UNITED STATES PATENT AND TRADEMARK OFFICE

APPLICATION NO.	FILING DATE	FIRST NAMED INVENTOR	ATTORNEY DOCKET NO.	CONFIRMATION NO.
10/524,811	08/10/2005	Andreas Fink	10191/3705	1654
26646 7590 12/18/2007 KENYON & KENYON LLP ONE BROADWAY NEW YORK, NY 10004			EXAMINER MITCHELL, KATHERINE W	
			ART UNIT 3677	PAPER NUMBER
			MAIL DATE 12/18/2007	DELIVERY MODE PAPER

Office Action Summary

DETAILED ACTION

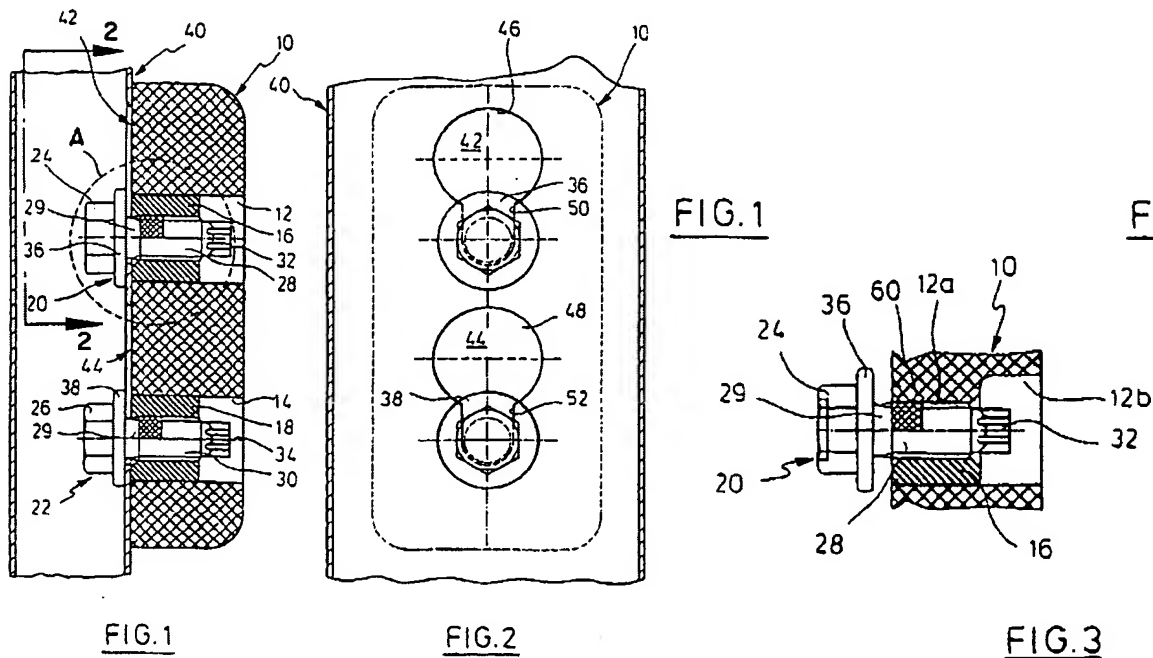
a self-locking (Column 3 lines 18-23, copied below) bolt 20 configured to be screwed into bushing such that it is guided with the head (24,36 is considered the head) through the larger opening (Fig 2) and head engages behind the smaller cut out, said bolt having tool engagement surfaces 32 at an end of the shank 28, and the head is round and has a smooth surface (at least 36 is round and has a smooth surface). Note that "36" is considered part of the head, and "36" is clearly the surface of the head that

is opposite (directly across from is assumed) the shank, not "24". "36" is round and has a smooth surface.

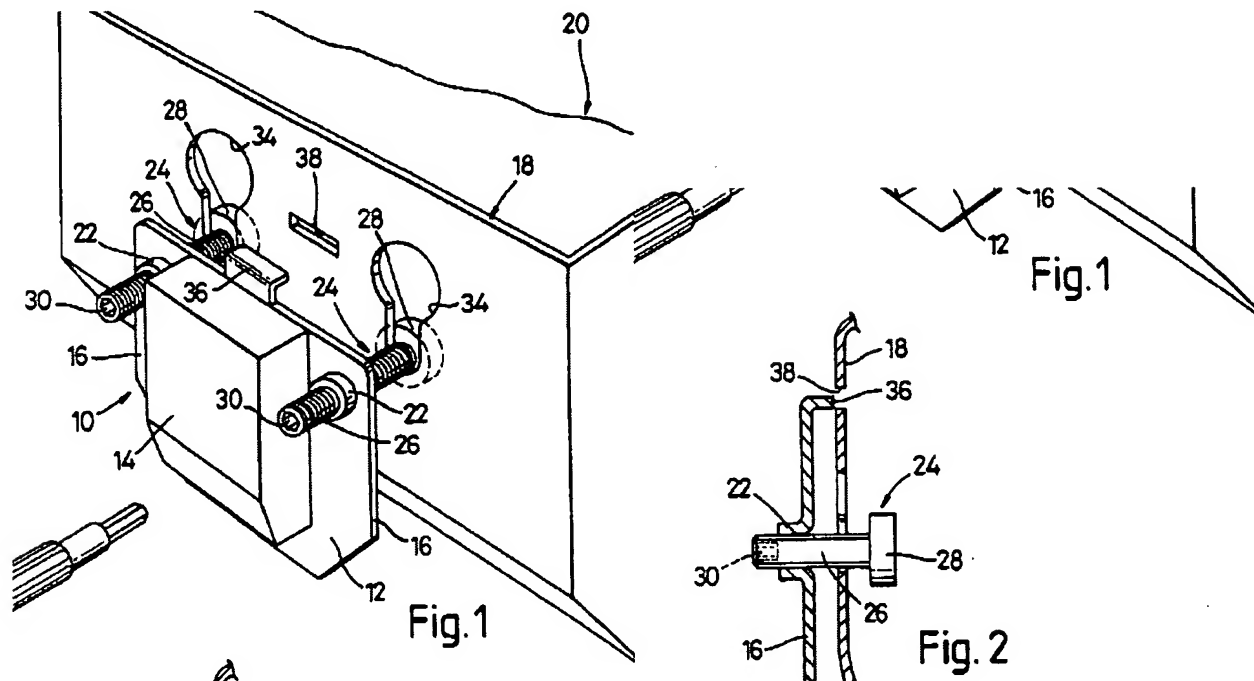
Threaded fasteners 20, 22 are provided with a head 24, 26, threaded shanks 28, 30 and ends 32, 34. The threaded shank 28, 30 are threaded into the inner threads of the inserts 16, 18. The ends 32, 34 of the shanks 28, 30 each have a Torx-portion. The heads 24, 26 have integrally formed radial flanges 36, 38. A non-threaded portion 29 joins the heads 24, 26.
